RFQ NUMBER
 DEP15705

ADDENDUM NO.1

ADDENDUM FOR FOR THE "LO-MING COAL" RECLAMATION PROJECT ISSUED TO DISTRIBUTE THE FOLLOWING INFORMATION AND TO MOVE BID OPENING DATE PER THE FOLLOWING.

**Addendum #1 - Questions During Pre-Bid Conference
For DEP15705
Lo-Ming Coal Corporation
Permits #O-5092-87, U-5023-97, U-5018-98, U-5085-88, U-5036-88, O-5035-88**

POND #4A - SPILLWAY PROFILE

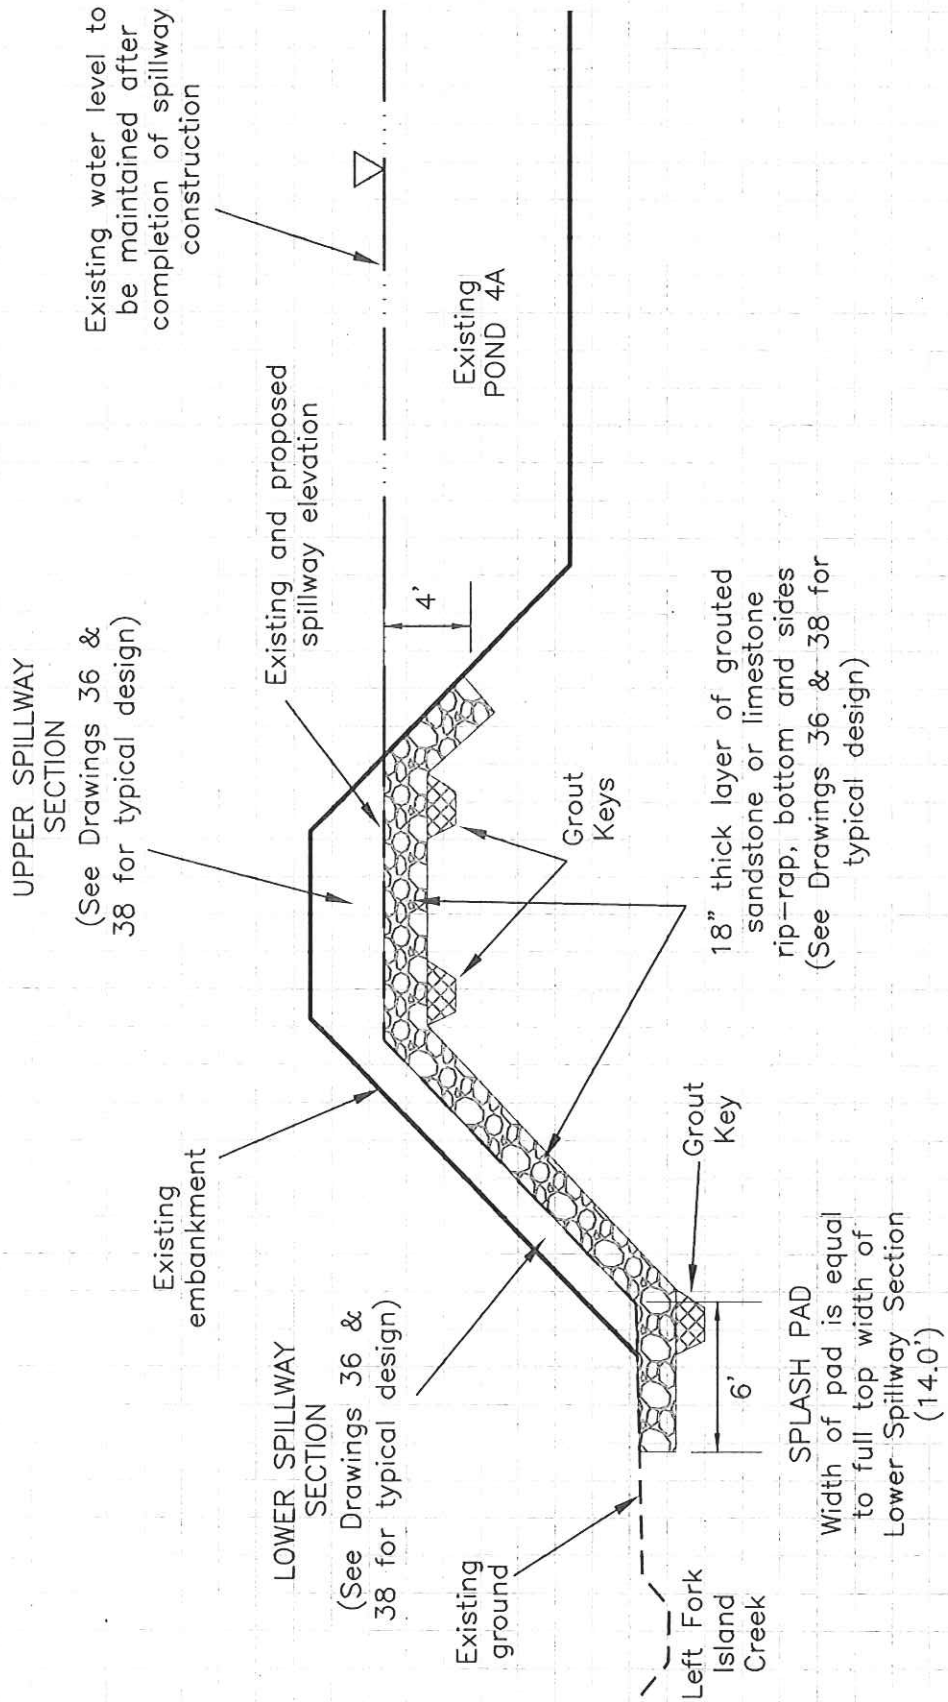
Bid Item #9.0: Reads 'repair' spillway for pond 4A. This will be changed to be a grouted rip-rap spillway. Revised specifications are attached, including design information for the spillway segments listed on Drawing #34 and a new Pond 4A spillway profile drawing.

A grouted rip-rap spillway shall be constructed at the dimensions listed on the plans (Drawing #34). The 'upper' spillway (horizontal portion) shall be formed to provide a finished six-foot (6') wide, four-foot (4') deep grouted rip-rap channel with 2h:1v side slopes. Final spillway elevation shall be the same as the existing elevation. The 'lower' spillway (sloped portion) shall begin at the horizontal section, incised into the outer embankment to form a finished six-foot (6') wide, two-foot (2') deep grouted rip-rap channel with 2h:1v side slopes. Grout keys shall be constructed at the inlet end, junction of horizontal and sloped portions, and outlet end at creek level.

PROJECT MAP: SHEET 4 of 6

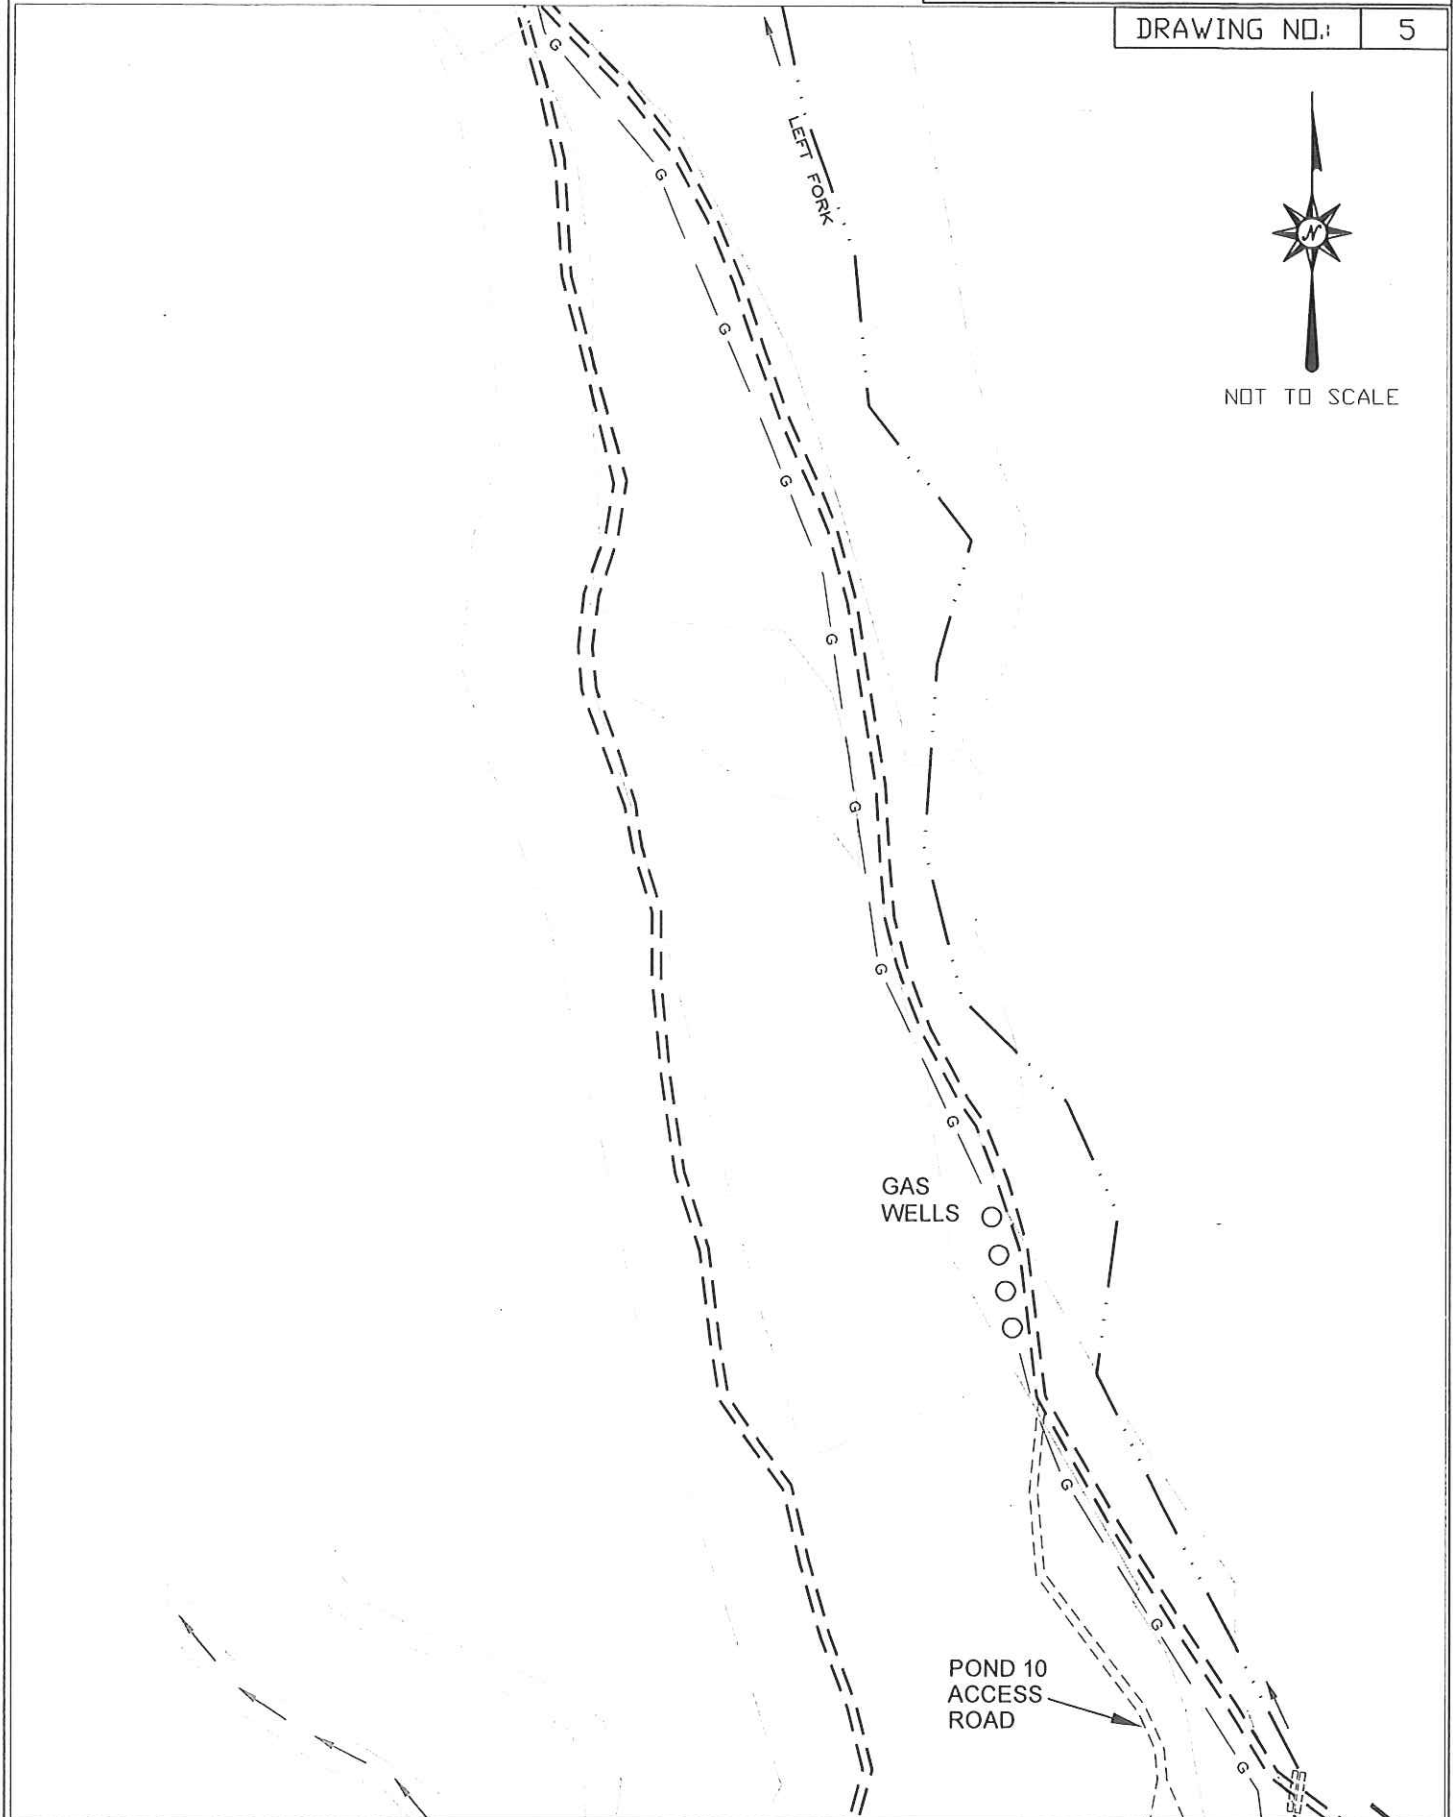
Drawing #5: The label to reclaim the existing refuse perimeter ditch is to be removed. This ditch work will not be performed under this contract. A revised Drawing #5 is attached.

DRAWING NO.:	38
--------------	----

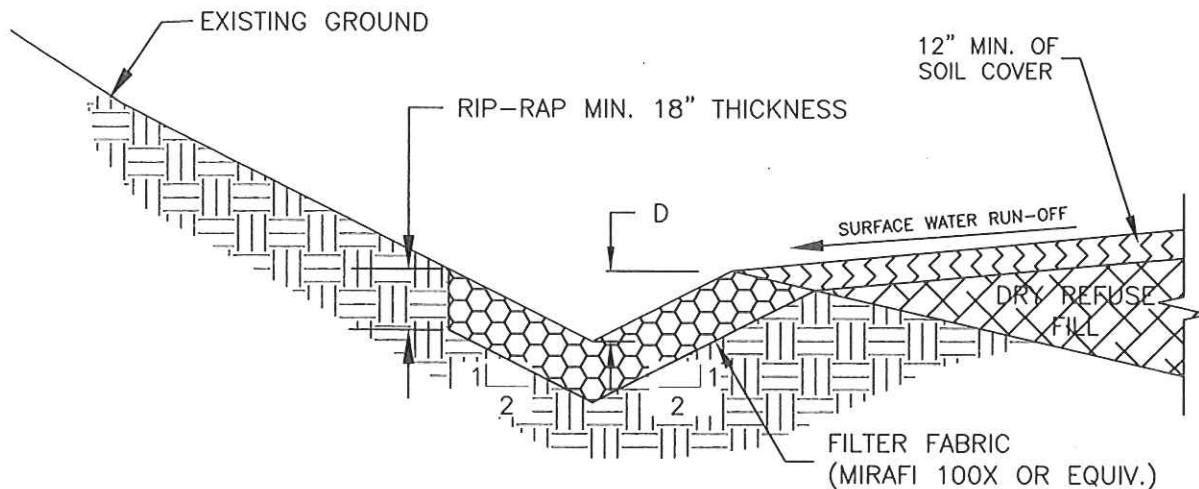
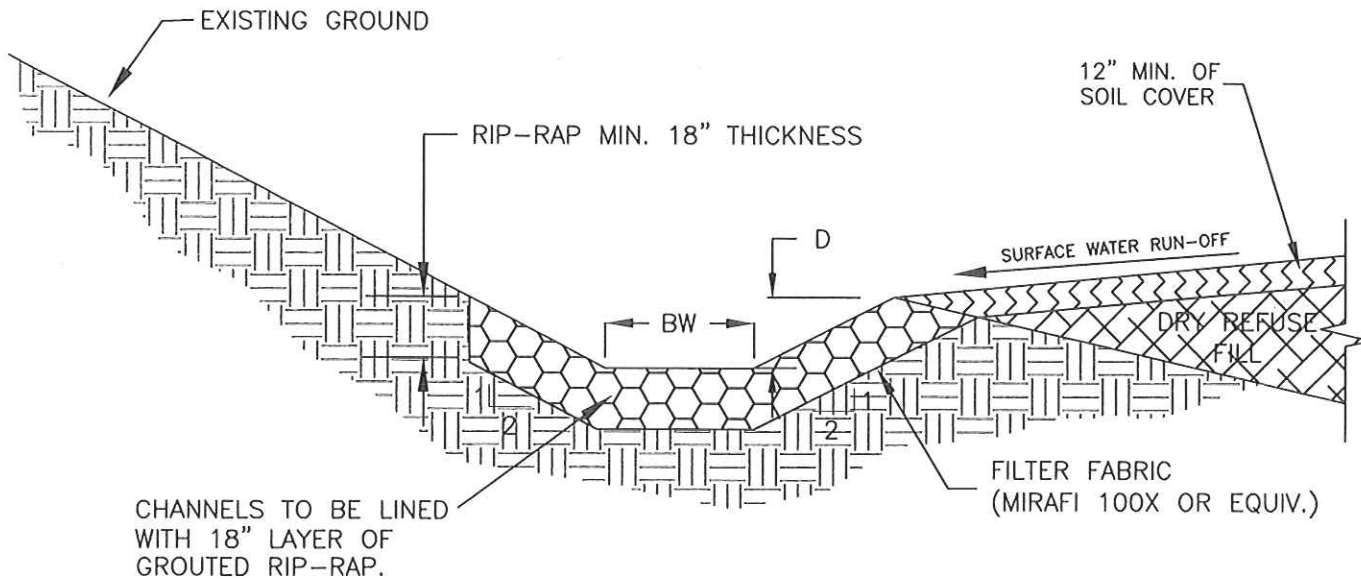
Bid Item #62.0: Specifications read that Ditches K and L are to be rip-rap or Fabriform. These are changed to be grouted rip-rap ditches. The Fabriform option is removed. Revised specifications are attached, including design information on Drawings #34 & #38 and a complete revised Bid Schedule (showing change for Item #62.0).

Provide all materials, excavate and construct ditch or channel as indicated on the attached typical plans, cross-section, specifications, and as discussed at the Pre-Bid Showing. Construct diversion ditches 'K' and 'L' around the perimeter of the top of the regraded refuse pile. The ditches will begin at the center of the fill and continue in opposite directions to connect with the beginning of their respective groin ditches. The ditches will be formed in original ground at the interface with the refuse fill by using the existing natural hillside.

Grout keys will be installed at the inlet, outlet and at other various critical locations of the ditches. See the attached drawings for exact location of grout keys.
